APPROACH SLABS E,F,G,H
CASTING LAY-OUT
REVISION # 1 11-19-13
REVISION # 2 12-6-13

| CAVENDISH ER BRF 0146(13) | |
| APPROACH SLAB 2 | SHEET NUMBER<br>8 |

APPROACH SLAB 2 ELEVATION VIEW

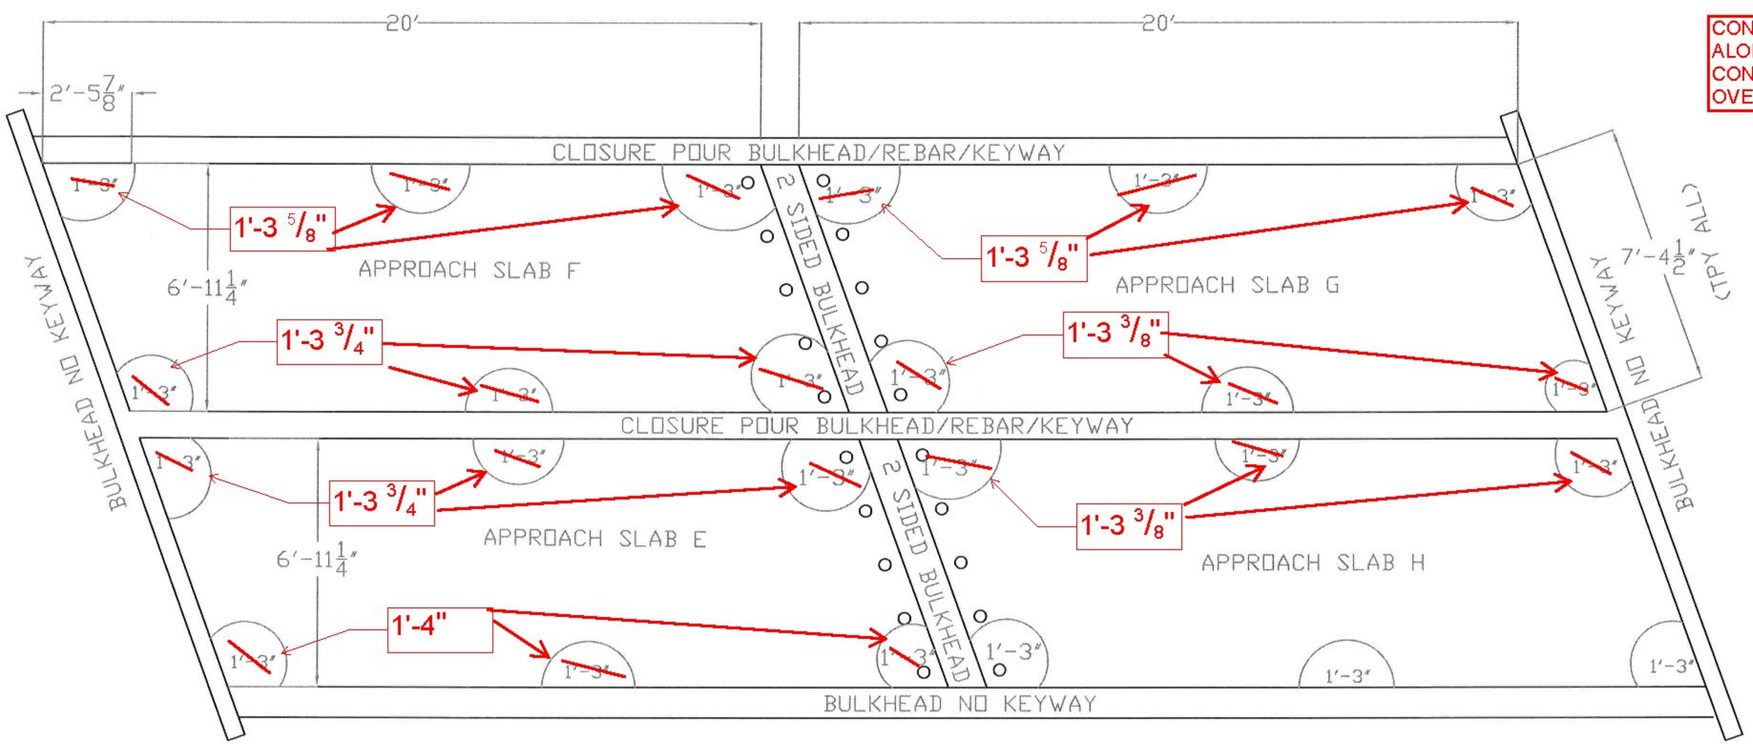
~~APPROACH SLAB # 2 THICKNESS HAS BEEN CHANGED BY THE PROJECT MANAGER TO A CONSISTENT 1'-3"~~

CONSTANT THICKNESSES ALONG EDGES, BUT NOT CONSTANT THICKNESS OVERALL
